Revision	Amendment or reason for issue	Issue date	Drawn by	Authorised
D	STAGE 2 ENTRY REVISED TO INCLUDE FENCING, GATE, INTERCOM, AND MAIL BOXES. NOTE 1	20-04-2011	R.H.	
C	SPOT LEVEL CORRECTED TO RL 18.00	00-04-2011	R.H.	
B	UPDATED FOR ADDITIONAL INFORMATION	24-03-2011	R.H.	
A	LANDSCAPING IN COMMUNAL OPEN SPACE ADDED AND LEVEL 1 ALTERED	11-11-2010	Z.D.

Surveyor MASTERS & ASSOCS	Date SEPT 2010	Drawing Title PROPOSED DEVELOPMENT GLADSTONE AVENUE, WOLLONGONG CONCEPT DRAINAGE LEVEL 1	Project No. KF109911
Date of Survey	Drawn A. PROUDLOVE		Drawing No. C03
Height Datum AHD	Designed A. PROUDLOVE		Sheet 3 of 5
Origin	Checked		Revision D
Horiz. Datum	Approved	Scale 1:250 @ A1 1:500 @ A3	Drawing Status ISSUED FOR DA APPROVAL

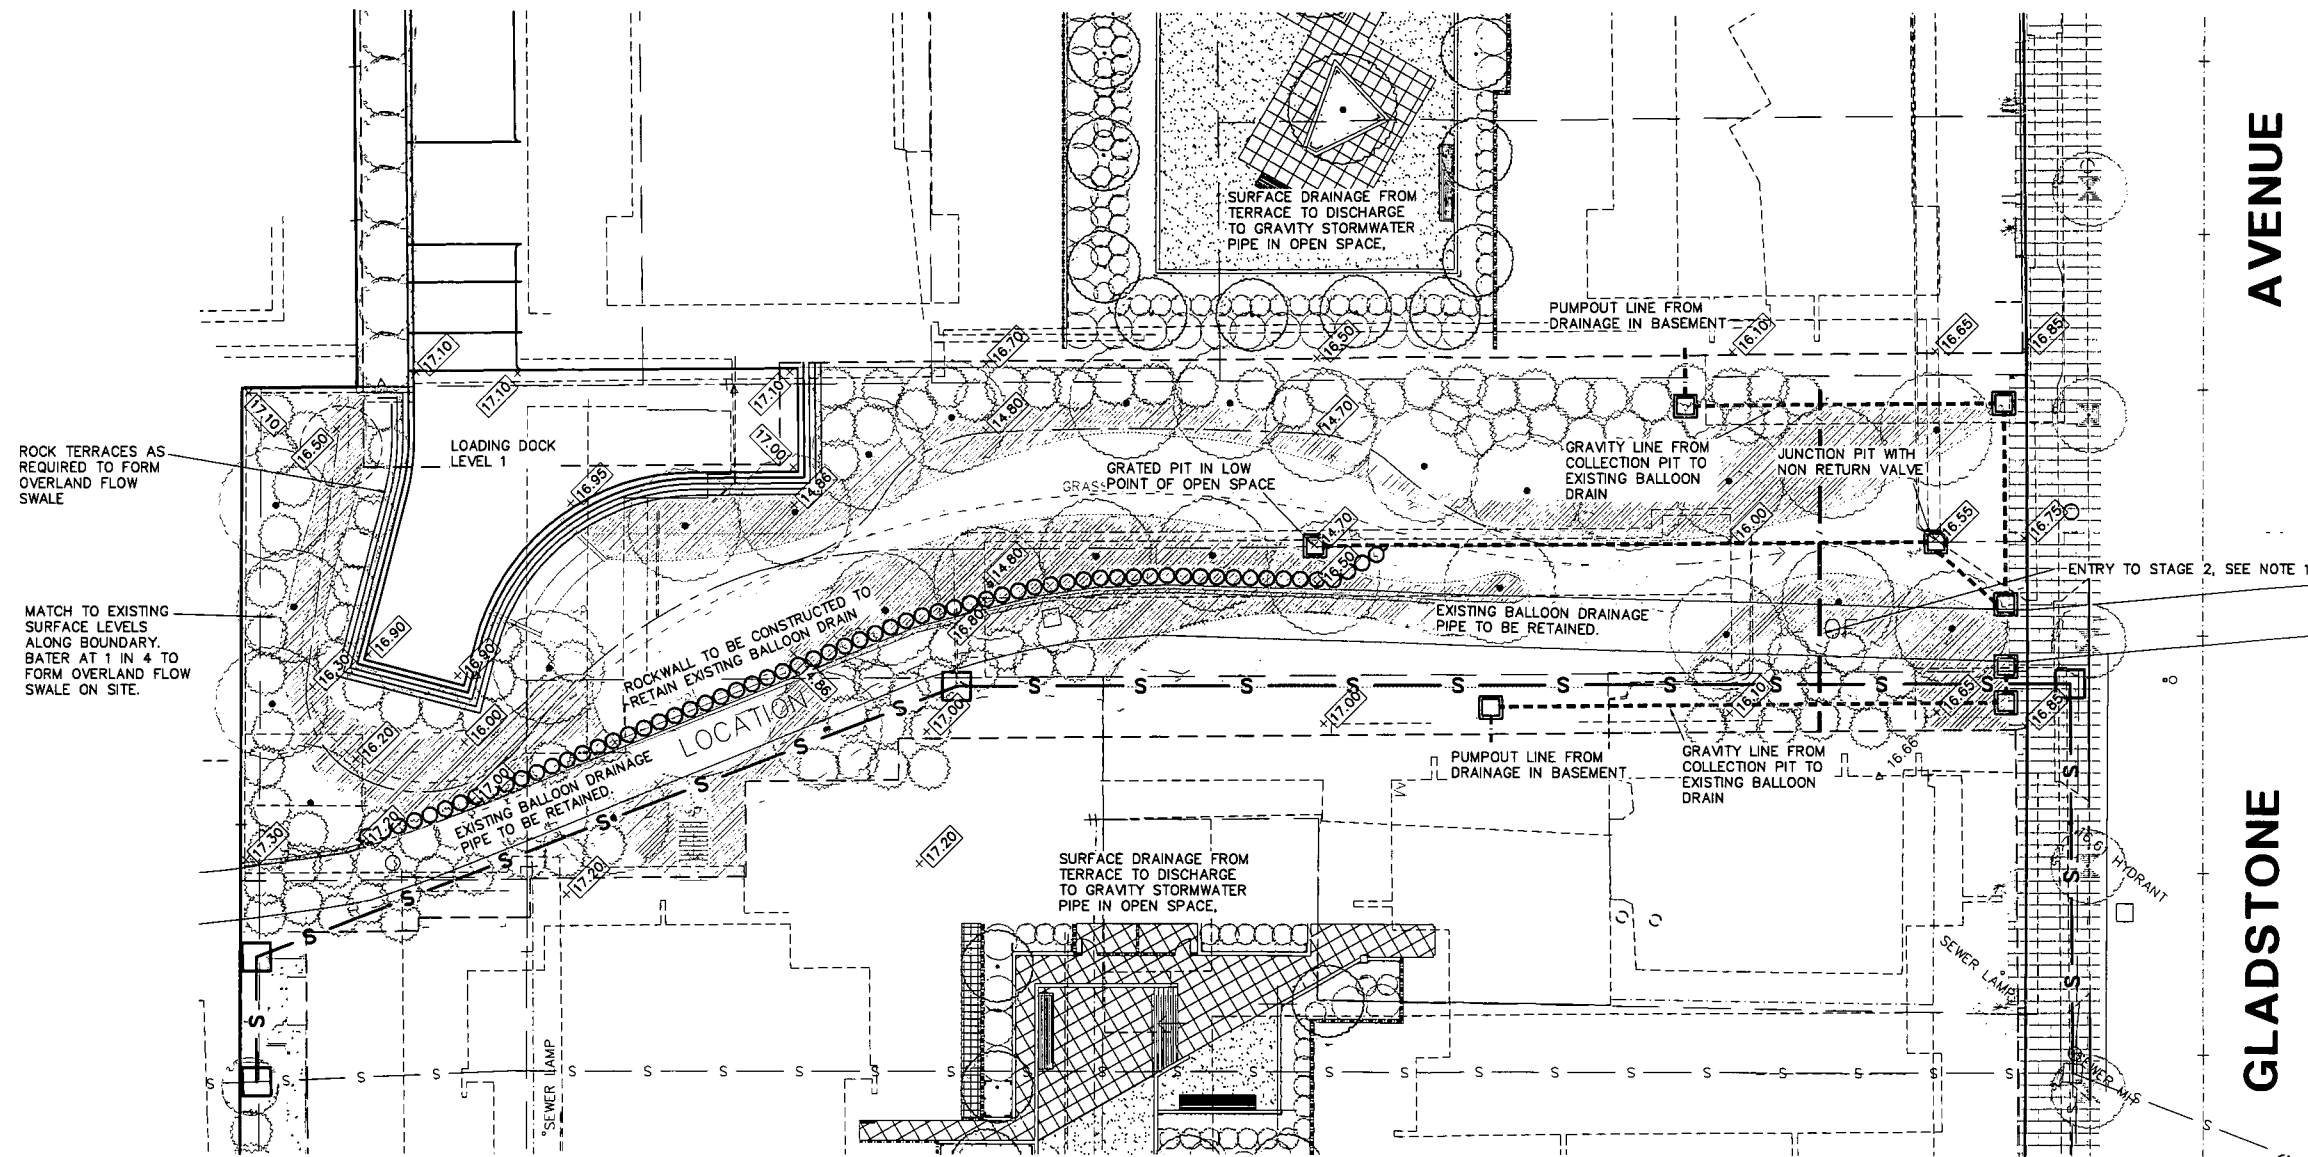
NOTE 1 ENTRANCE TO STAGE 2

OVERLAND FLOW PATH TO BE FENCED ALONG GLADSTONE AVE WITH COLLAPSIBLE FENCING IN ACCORDANCE WITH DRAINAGE REQUIREMENTS.
FENCE PROVIDED WITH GATE AND INTERCOM SYSTEM FOR ACCESS TO GROUND FLOOR UNITS IN STAGE 2.
MAIL BOXES TO BE INCORPORATED AT THE ENTRY TO STAGE 2.

FENCING DESIGNED TO COLLAPSE UNDER FLOOD LOADING SO AS NOT TO INCREASE FLOOD LEVELS. FENCE TO BE ANCHORED TO AVOID BEING WASHED AWAY. LOW STRENGTH TIES TO BE USED TO HOLD THE FENCE IN PLACE DURING NON-FLOOD TIMES.

Project No.	
KF109911	
Drawing No.	
C05	
Sheet	Revision
5 Of 5	D

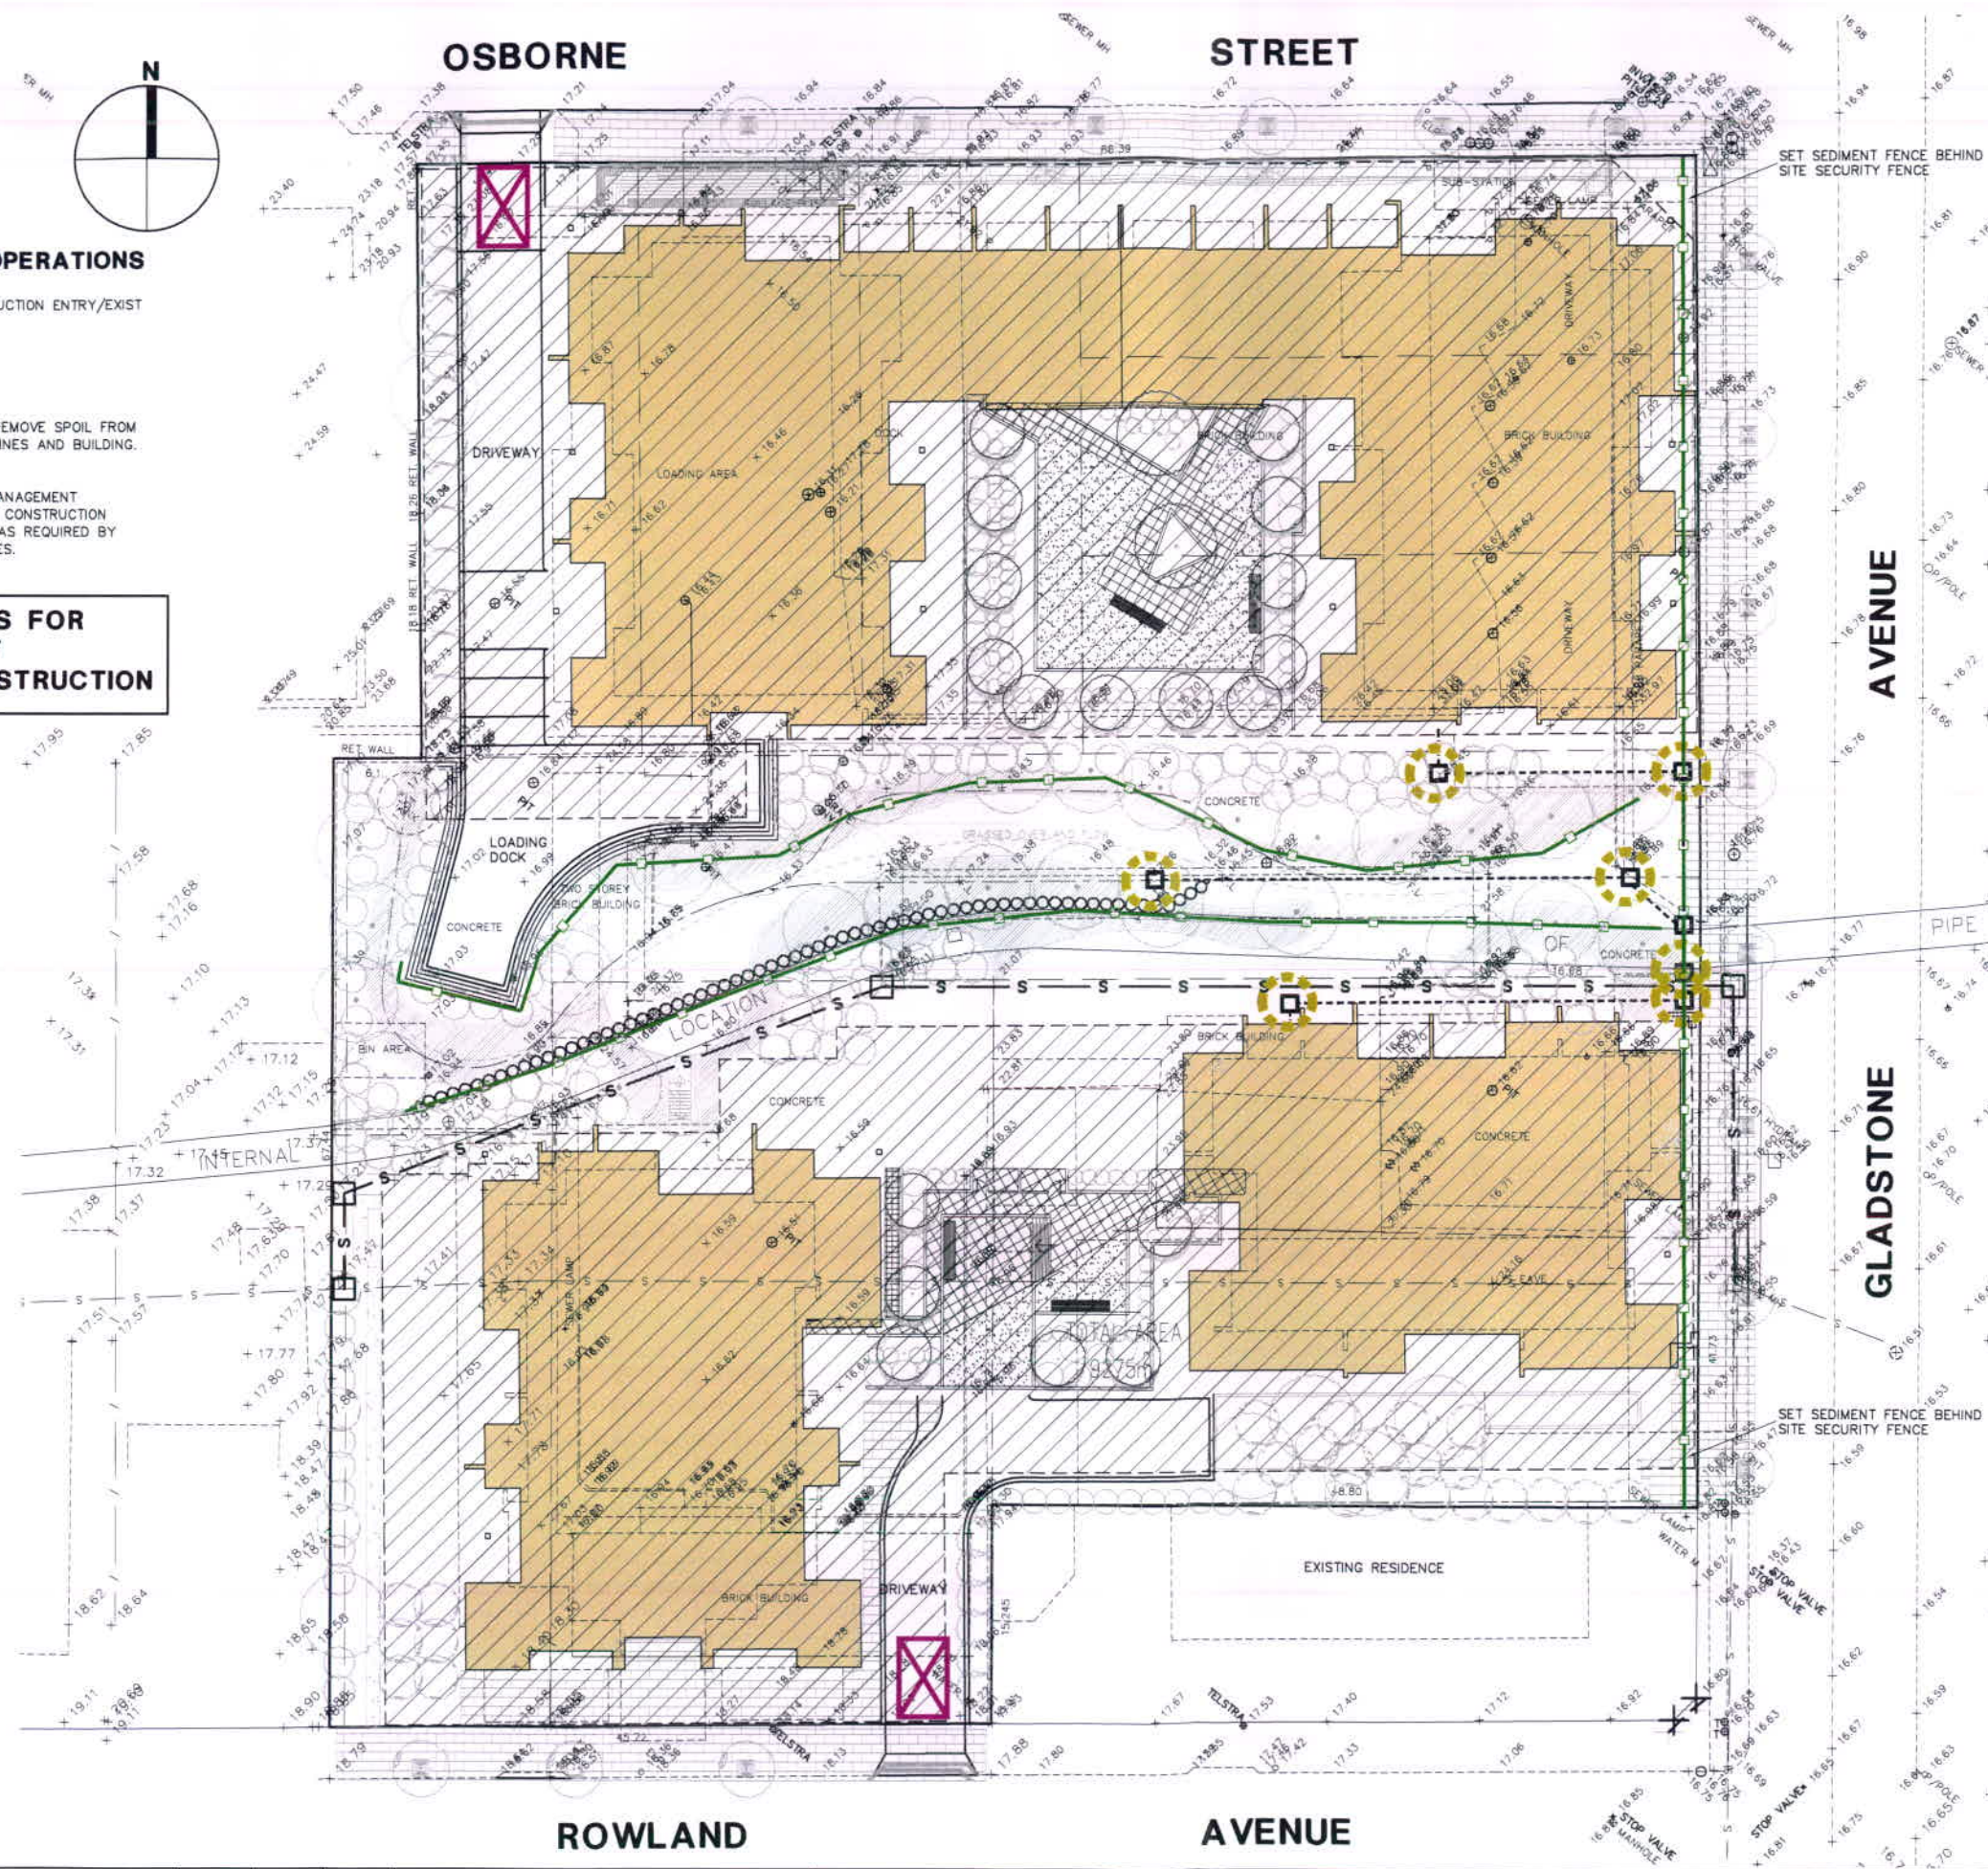
D	STAGE 2 ENTRY REVISED TO INCLUDE FENCING, GATE, INTERCOM. AND MAIL BOXES. NOTE 1	20-04-2011	R.H.		
C	UPDATED FOR ADDITIONAL INFORMATION	24-03-2011	R.H.		
B	EXTRA LEVELS ADDED IN OPEN SPACE	30-11-2010	A.P.		
A	LANDSCAPING IN COMMUNAL OPEN SPACE ADDED	11-11-2010	Z.D.		
Revision	Amendment or reason for issue	Issue date	Drawn by	Authorised
